Addendum No. 1

Joliet Junior College
1215 Houbolt Road
Joliet, IL 60431

TO: Prospective Bidders
SUBJECT: Addendum No. 1
PROJECT NAME: T-Building Restroom Renovation
JJC PROJECT NO.: B25005

A1

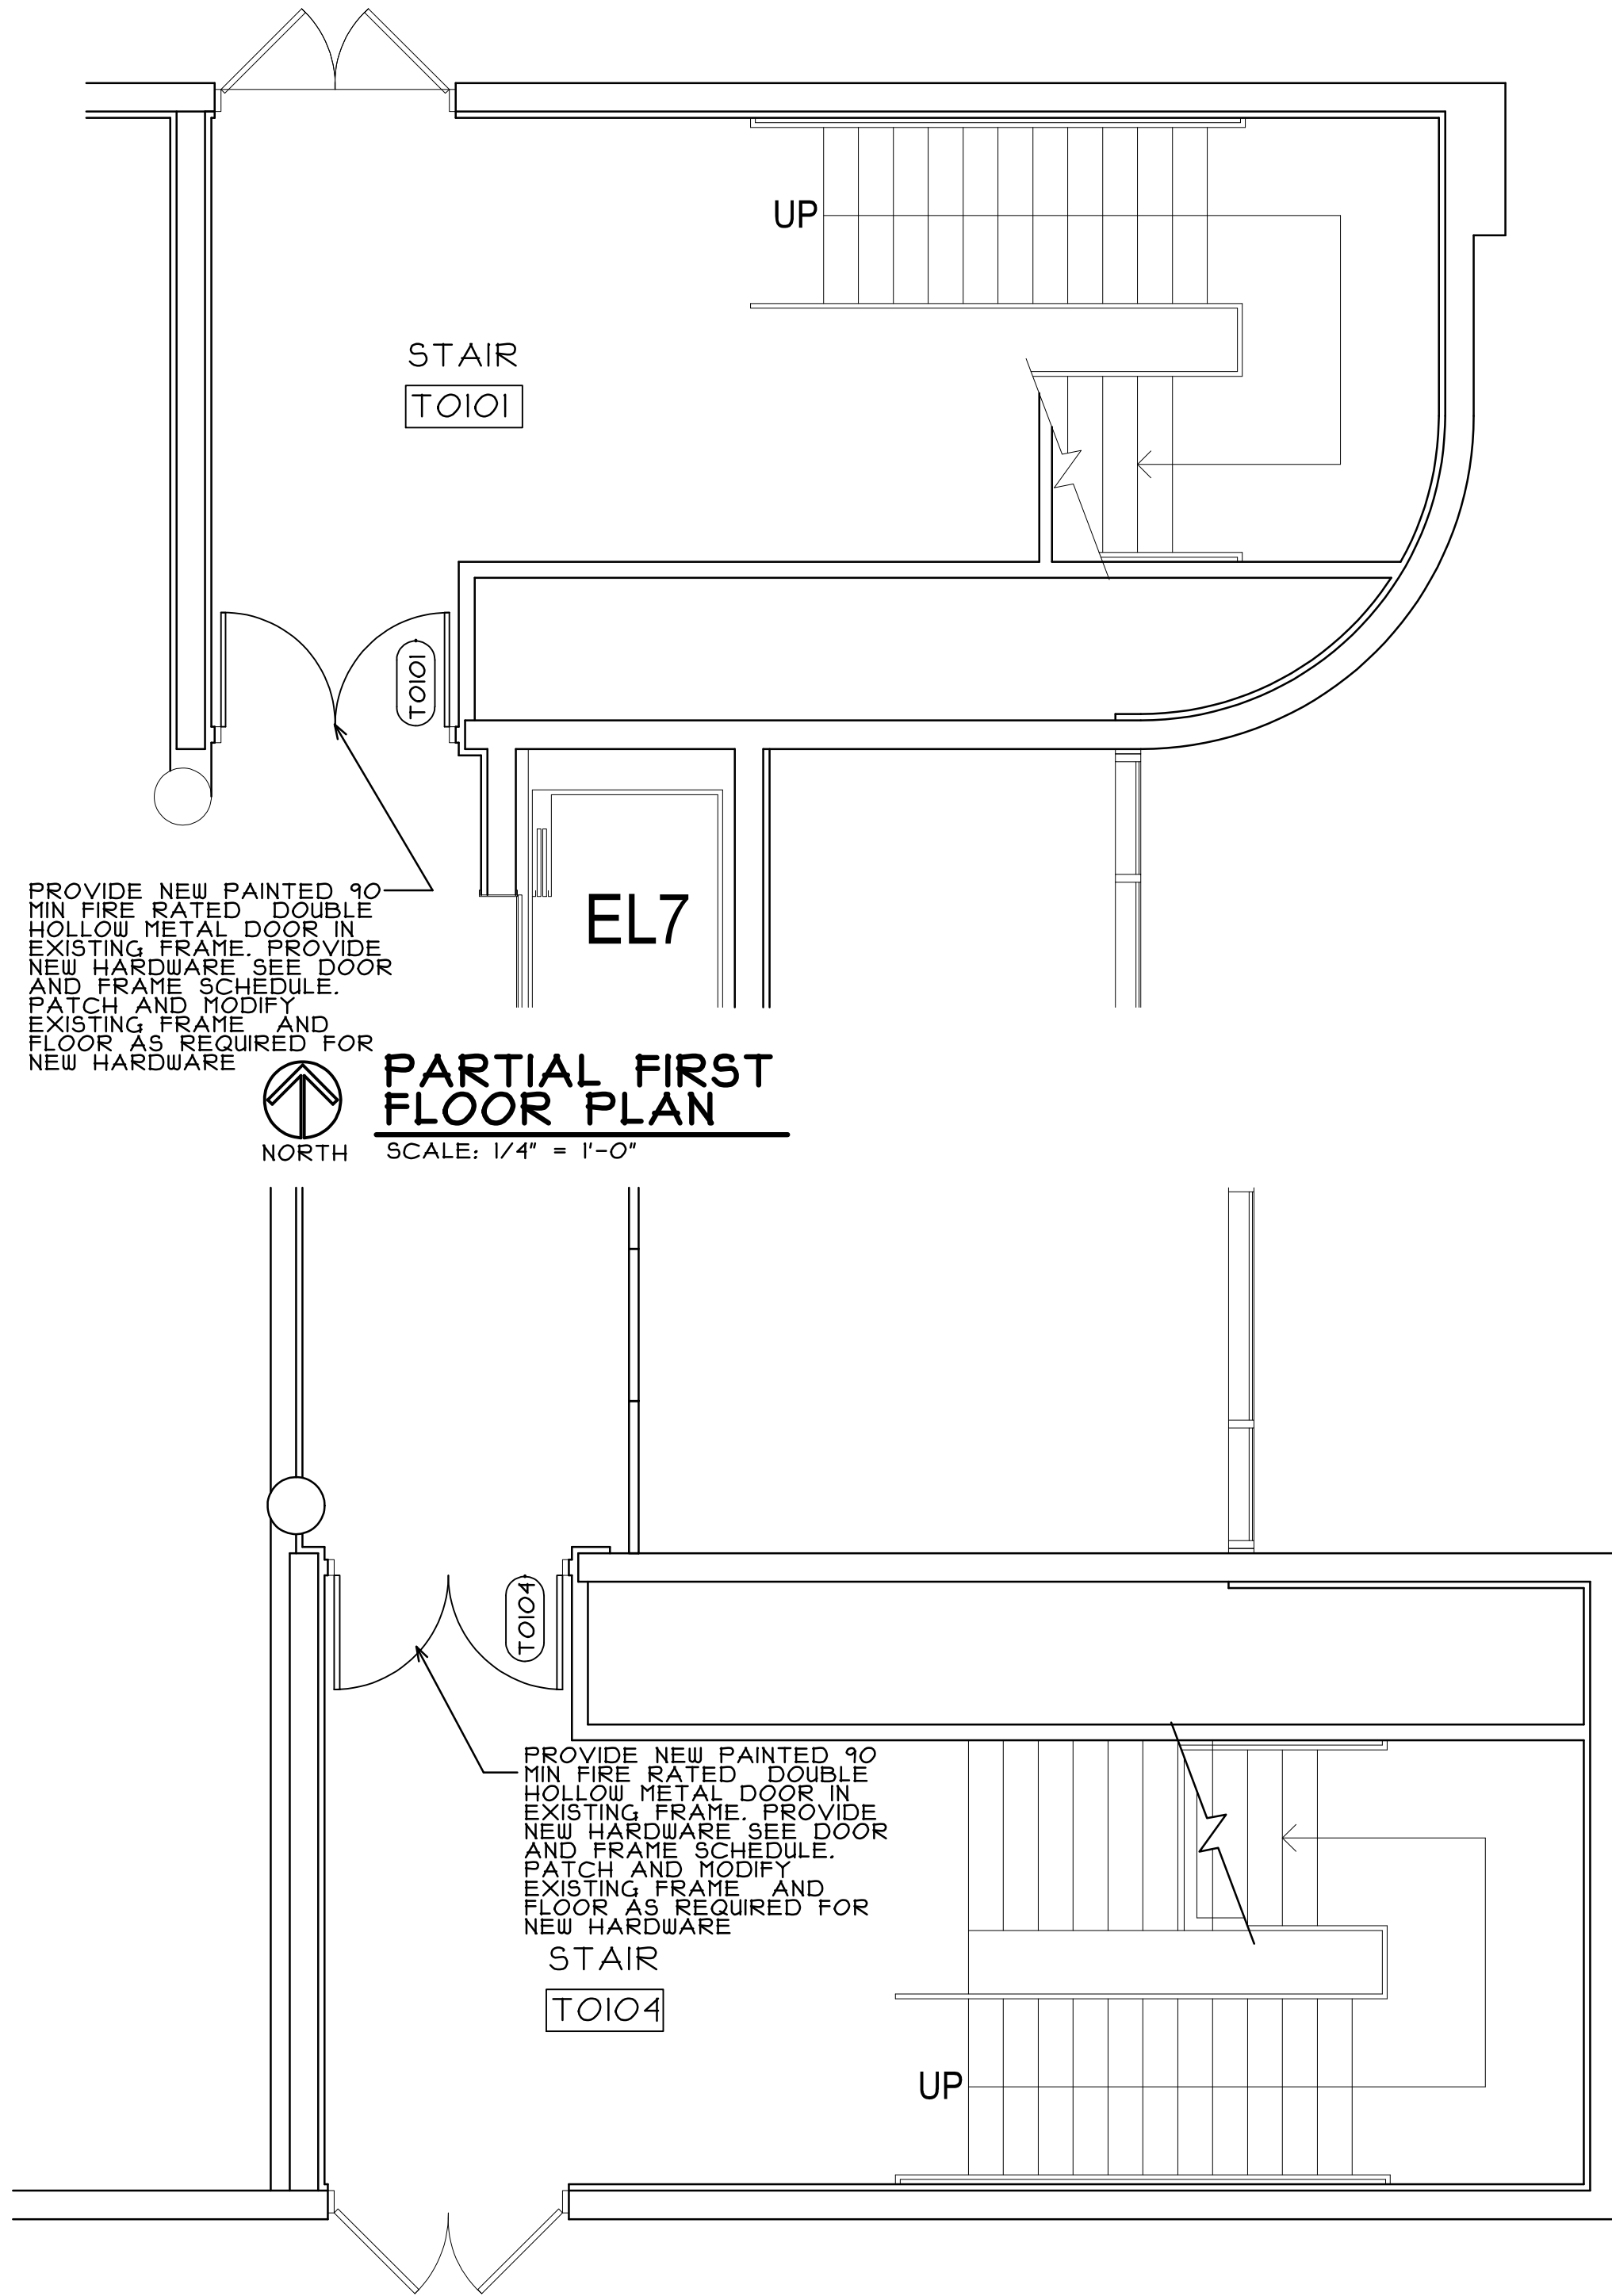
3. Please confirm if the South wall is to receive new full height wall tile and base on new tile backer board as indicated on Sheet A1, keynote #2.

8. On sheet A1, all toilets are labeled WC-1 and they are designated as ADA compliant toilets. All existing toilets are at standard height ranging from 14-16 inches to top of bowl rim but ADA is about 17-19 inches to top of toilet seat. Do all of the toilets being installed need to be changed to ADA heights?

10. On Sheet A1 it states to install a stainless-steel wall guard but on Sheet A3 it states to use a solid surface wall guard. Which is being used.

13. Plans call to remove the old hand dryers and reuse them. The drawing is showing a new model to be installed. Which is correct?

Answer: Per note two all walls to receive full height wall tile which is noted as typical which includes the south wall.

Answer: Toilets are wall mounted fixtures (fixture noted is an ADA compliant fixture) non-ADA stalls can be mounted at existing height. Only ADA stall to be mounted at ADA height.

Answer: Provide solid surface wall guard.

Answer: Demo plans call for existing hand dryers to be removed and existing wiring to remain for reuse not to reuse hand dryers. Sheet A1 calls out new Hand Dryers model to be installed.
